Subject: Rice Solar Energy Project (09-AFC-10)  
Response to CEC Staff Data Requests 130, 139-141, 143-144

# Rice Solar Energy Project

**Response to CEC Staff  
Water Resources Data Requests 130, 139-141, 143-144**

## FIGURE DR130-1 WELL LOCATIONS

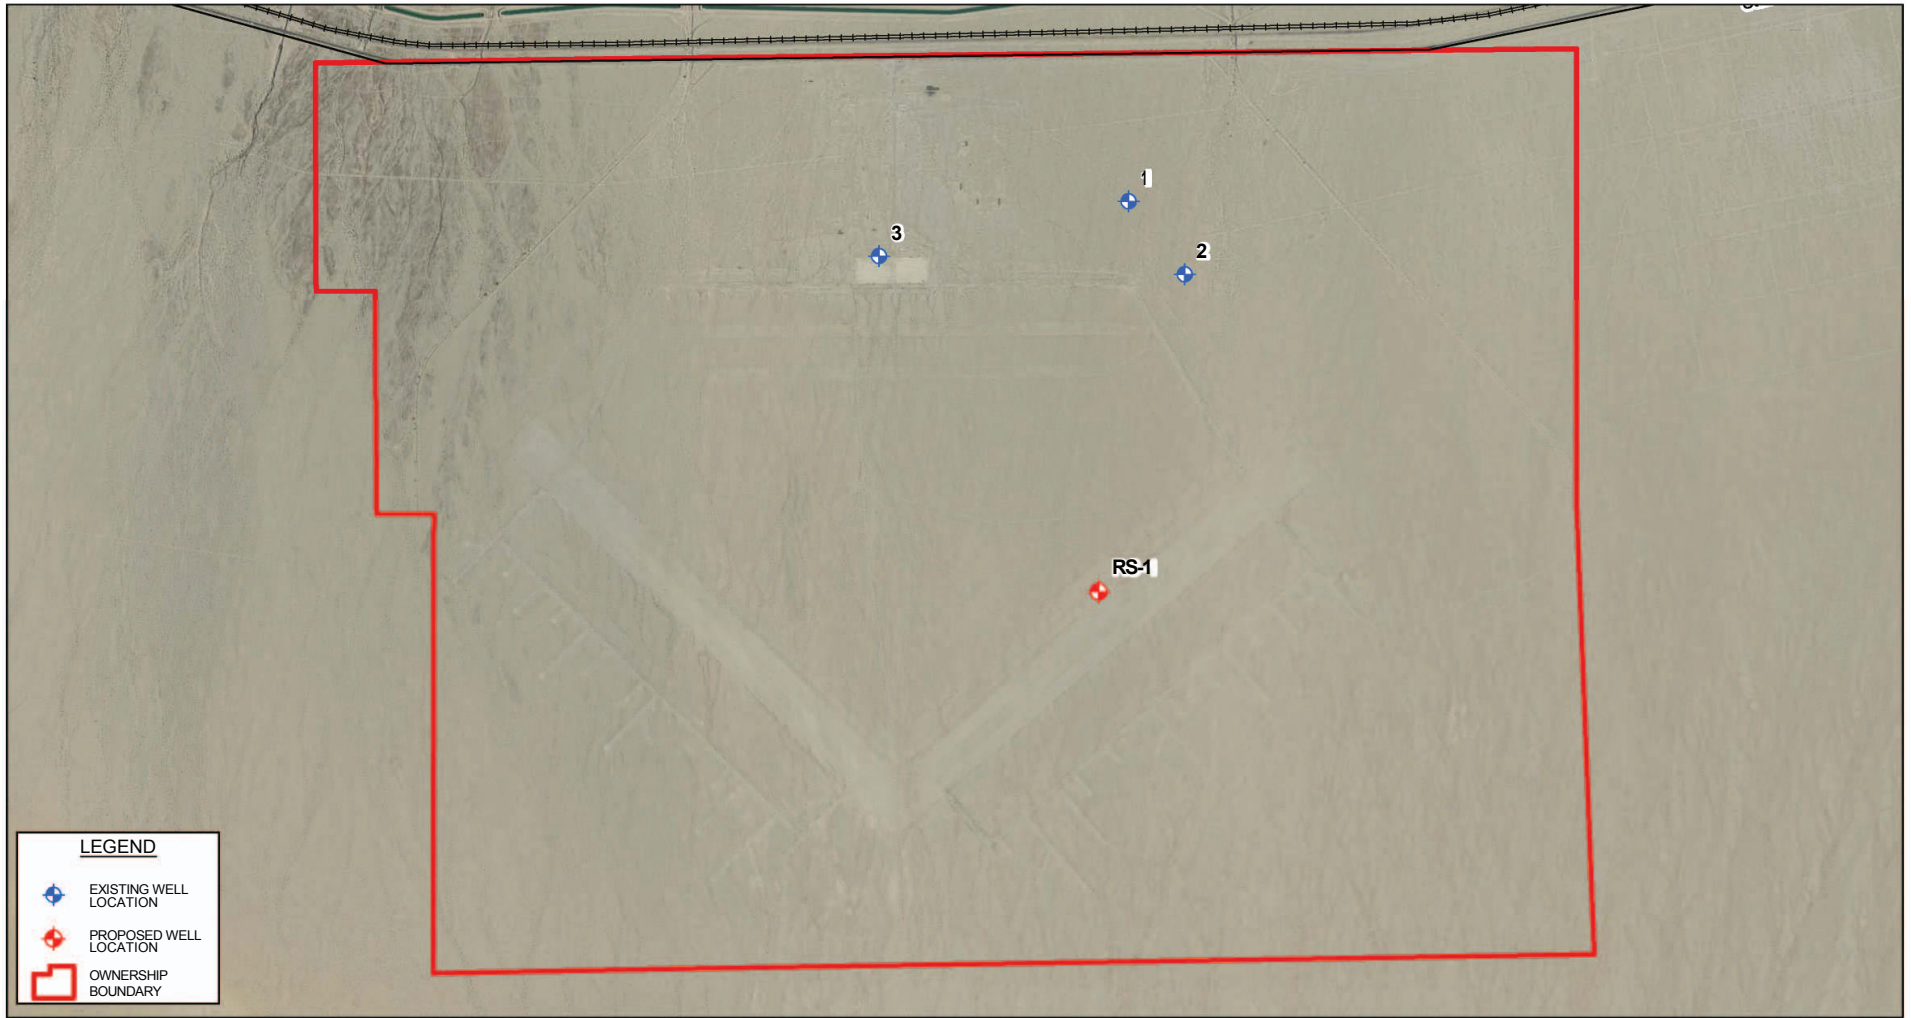
- a. Please be sure to include draft well completion diagrams as well as a site map showing existing and proposed well locations; and*

**Response:** Three wells currently exist on site, as presented in Table 1 and Figure 2 of the Rice Groundwater Resources Investigation Report (WorleyParsons, 2009; provided as AFC Appendix 5.15A and referred to herein as GRI Report). Rice #1 is completed in the upper alluvium and is not suitable as a source of water for the RSEP because of low yield and high total dissolved solids (TDS) in the groundwater. Rice #2 is completed in the lower alluvium and underlying Bouse Formation, and is currently unused. Rice #3 is noted by the U.S. Geological Survey (USGS) as being obstructed above the water surface.

The GRI report proposes that two wells, Rice #2 and a new well, RS-1, are required to meet construction water demand and to provide full redundancy of the operating water supply. Because Rice #2 is screened in the lower alluvium and underlying Bouse Formation, modifications to this well are necessary. Rice #2 will be filled with cement grout to the base of the lower alluvium at a depth of approximately 810 feet below ground surface (bgs). Additionally, one new well, RS-1, will be drilled early in the construction phase to supplement Rice #2. This well will be constructed between 8 and 16 inches in diameter and screened in the lower alluvium from approximately 635 to 805 feet bgs. The final screened interval will be determined based on the results of a pilot boring that will be drilled at the proposed well location. The location of the proposed well is shown in Figure DR130-1 and the anticipated well construction details are included on the well schematic in Figure DR130-2.

**FIGURE DR139-1  
RICE VALLEY WATERSHED AVERAGE  
ANNUAL PRECIPITATION**

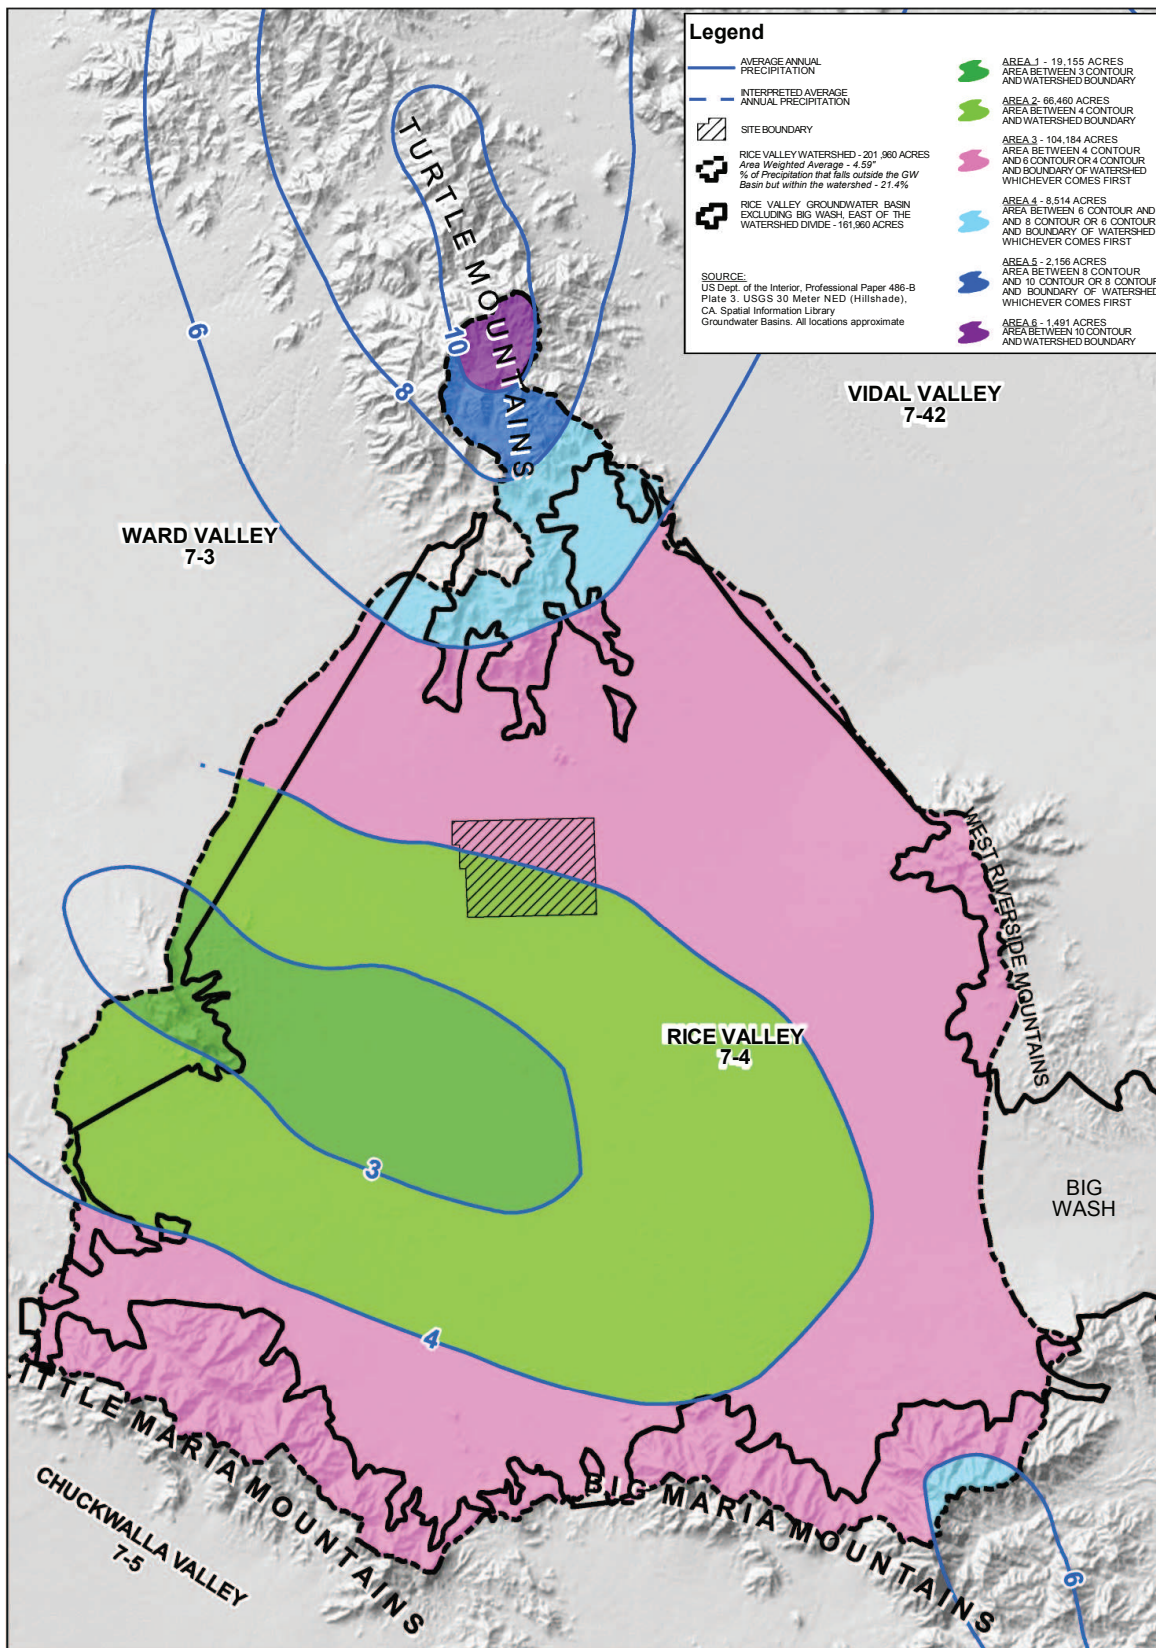
139. *Please provide more detailed or different analysis of Rice Valley basin recharge (or adjacent valleys if necessary) using methods such as Maxey-Eakin (1949) or modified methods such as Donovan and Katzer (2002).*

**Response:** In this part of California, almost all moisture from rain is lost through evaporation or evapotranspiration and runoff occurs principally during intense thunderstorms (RWQCB, 2006). Most recharge from precipitation occurs when runoff from the surrounding mountains exits bedrock canyons and flows across the coarse sediments deposited in the proximal portions of the alluvial fans that ring Rice Valley. To a lesser extent, recharge occurs from infrequent precipitation or runoff on the valley floor (DWR, 2004). The area of the Rice Valley watershed encompasses Rice Valley (161,960 acres) and the surrounding bedrock mountains (40,814 acres), for a total area of approximately 202,774 acres (Figure DR139-1).

For this study, recharge from precipitation was estimated by overlaying isohyetal maps prepared by Hely and Peck (1964) on the Rice Valley watershed boundaries and calculating the volume of average annual precipitation for each of six precipitation zones for the valley and bedrock portions of the watershed, as shown in Figure DR139-1. Recharge was then estimated as 2, 3, 5, and 10 percent of total incident precipitation and a reasonable lower bound recharge estimate was adopted. The area to the east of the interpreted groundwater flow divide within Big Wash was excluded from the calculation because this area drains to the Colorado River. The calculated average annual precipitation volume for the Rice Valley watershed is 77,250 acre feet based on an area-weighted average precipitation of 4.59 inches
